INTER-OFFICE MEMORANDUM

TO:	Planning Office	SUBJECT:	POD2013-00095: Three Chopt Retail at 9911 Three Chopt Road
FROM:	Henrico County Police Division, Community Services Unit	DATE:	April 11, 2013

POD2013-00095

Three Chopt Retail at 9911 Three Chopt Road

Photo A. Shielded wall pack.

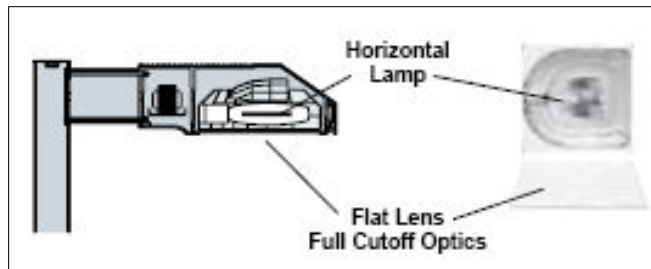
3. All light fixtures need to be full cut-off. See Photo's A and B for examples of full cut-off wall packs and pole lights.
4. Should post top fixtures be used, these fixtures also need to be full cut-off so that the light will be directed down to the ground, versus horizontally and up in the air. If decorative fixtures are installed, they should have the lamp in the top casing of the fixture so that the light will be directed towards the ground (See Photo C). This will also avoid glare because you don't actually see the lamp. Glare is defined as horizontal light that hinders vision.
